Prepared by the secretariat

FRAV-VMAD-01-02/Rev.3
1st FRAV/VMAD session
29-30 November 2023

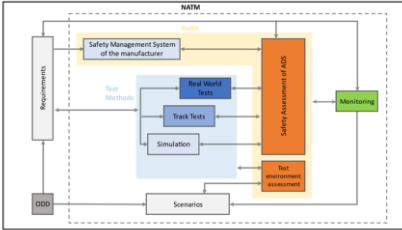
116	These pillars are intended for use in combination(s) to produce an efficient, comprehensive, and coherent assessment of ADS compliance with the guidelines on safety performance. Figure [1] below illustrates relationships across the ADS safety requirements, ODD analysis and	UK comment Some commentary around the links on this diagram would be helpful.

Original draft text	Comments/Proposals	Discussion Outcome(s)
117	<p>Figure 1. Relationships across safety requirements, ODD analysis and scenario generation, and validation pillars</p> 	<p>OICA/CLEPA proposal</p> 	<p>UK: good update to diagram, could be improved to be easier to read and meet WP.29 admin formatting if any. Possibly add labels to lines for clarity. Canada chair: Previous diagram not wrong. New diagram provides more details. Depends on whether you are a “visual” person. Supposed to be illustration of concept being put forward. Details found in document. May be overcomplicating diagram. Information needs to be accurate. Is there a real need for change? DG: Interest in illustrating combined FRAV and VMAD contents. Canada chair: If motivation coming from FRAV to recognise work in diagram, not necessarily here. SAE: Since ODD so central to what an ADS is, the new proposal clarifies this. See as improvement towards advancing understanding while recognising Canada comments. UK: first diagram designed to describe VMAD components, so support update, especially ODD. Serves purpose of improvement to capture contents of section. Support moving forward with diagram that captures additional content. ETSC: new diagram loses sequency of original diagram. Concern with arrow into audit, learning something from ISMR prior to start of audit. OICA/CLEPA: agree on matter of taste, propose to keep original but include ODD based framework. Scenario database not sole source of truth. Could modify left-side of original diagram.</p>

<p>Canada chair: Agree with proposal. We can see how that looks.</p> <p>Decision: Revised diagram (Matteo point of contact) for Tokyo session.</p>
118		<p>OICA/CLEPA proposal (4 paras.)</p> <p>Figure [1] provides an holistic overview of the interconnections of the ADS functional requirements, the scenario generation approach and [applicable] validation pillars.</p>	<p><i>End of Day 1.</i></p>
119		<p>In the figure above, the operational design domain underpins the application of relevant requirements and provide an input to the scenario generation approach.</p>	
120		<p>It is recognised that some requirements are specific enough and/or ODD independent and therefor can be assessed directly by means of one of the test methods and/or audit, as shown.</p>
